Within our approved planning application, we had included to retain an old disused chimney including the stack on the existing kitchen wall side (lefthand side when viewed from the street). Our builder has recently discovered that the original disused chimney is not properly supported and therefore has structural support problems. See the photo below: -

PROPOSED SIDE ELEVATION

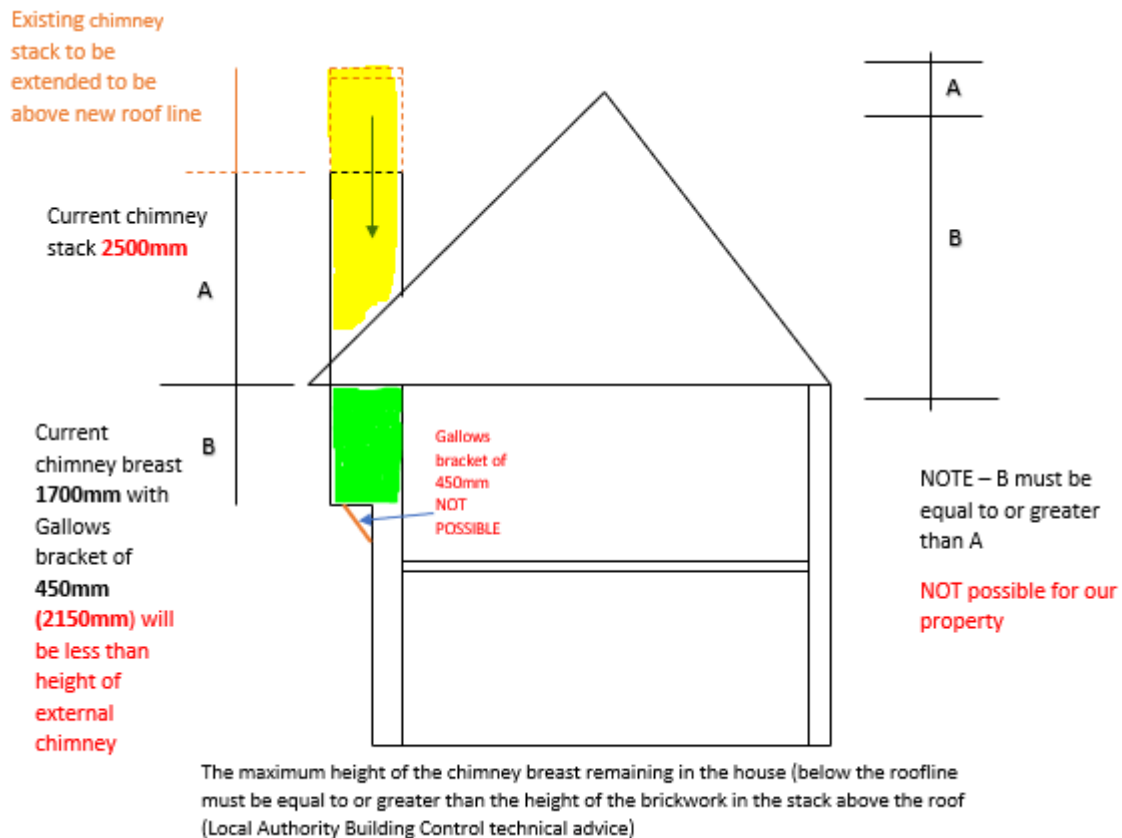
The builder has very strongly advised us that for structural and safety reasons, it would be advisable to remove the chimney completely as there is no longer a need for this old chimney in the kitchen. This is because the fixed height of the internal chimney breast detailed in green will not be able to support the much larger external chimney stack in yellow, which must be extended as shown within the diagram below:

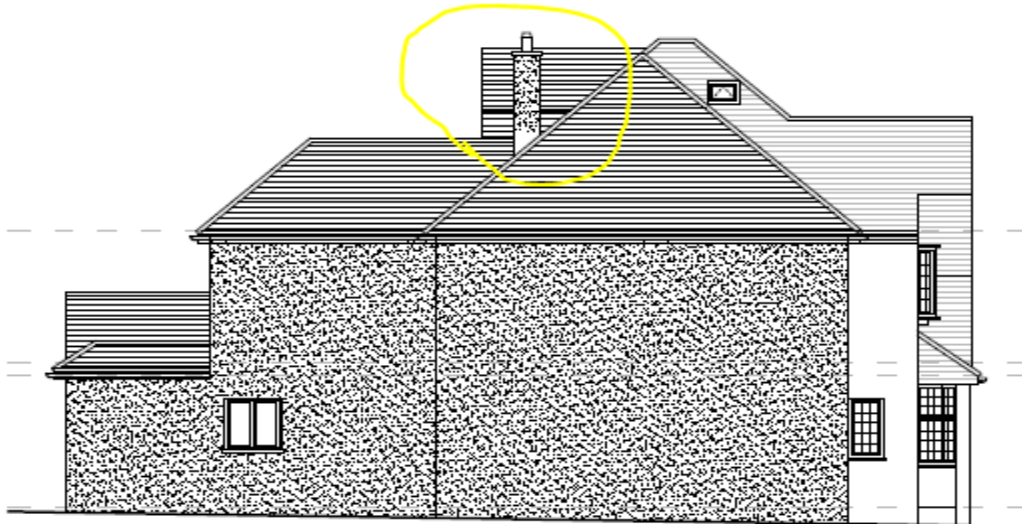
The diagram is showing that the **external** chimney stack is currently approximately 350mm greater than the **internal** chimney breast and will need to be increased even further to go above the new roof line as per planning approval. The height of the current chimney is further confirmed by the photos below: -

Therefore, the newly extended chimney stack will **not** be adequately supported below and will be structurally unstable **not** only from insufficient base but also from wind and rain, even if the gallows bracket were installed to support the base.

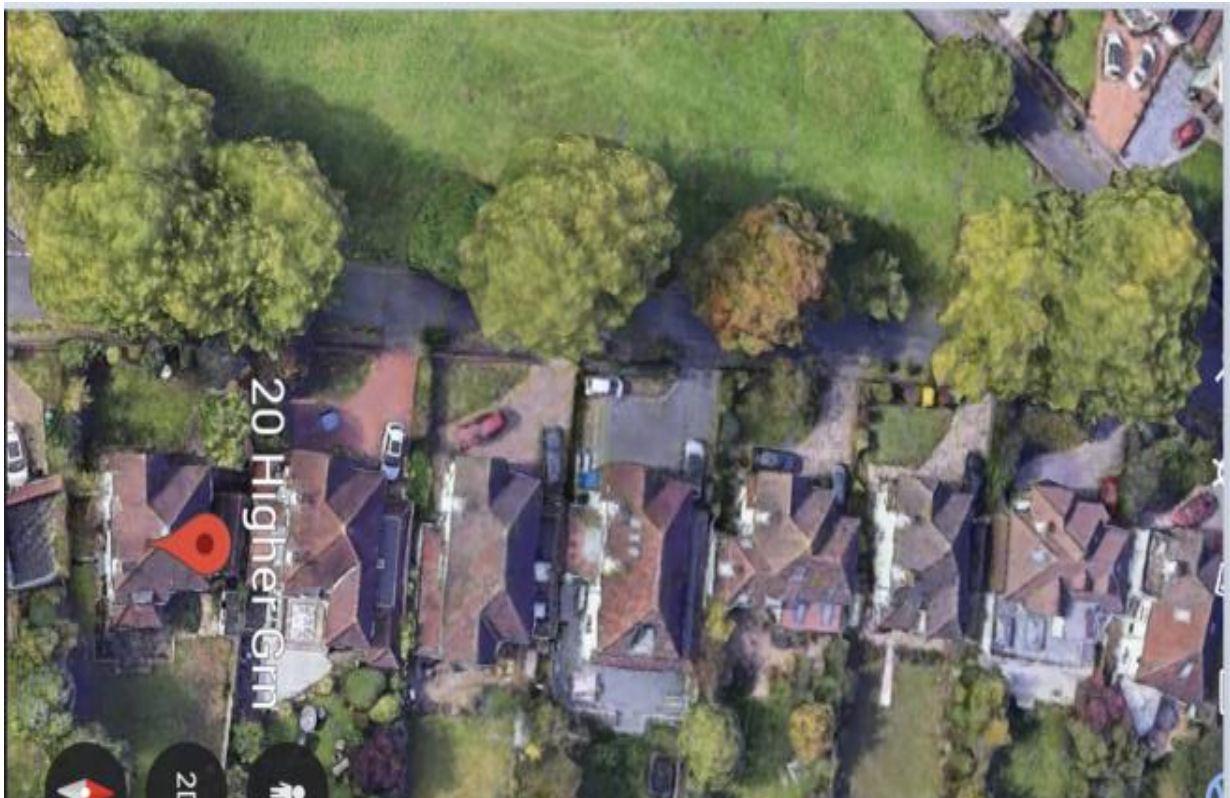
In addition to this, the positioning of the chimney stack being very close to the side valley of the roof, will result in water penetration within the roof structure from the rain water gushing down the roof valley, causing leaks and damp. This problem of the valley and close proximately to the chimney is becoming very apparent as we are shortly to commence the new roof structure construction.

At the time of putting the planning application we were not aware of the problems that we would have with renovating a disused old chimney for aesthetic purposes only as it cannot be used. Therefore, I would be most grateful if you could accept the builder's very strong advice based on LABC technical advice, to remove the chimney completely.
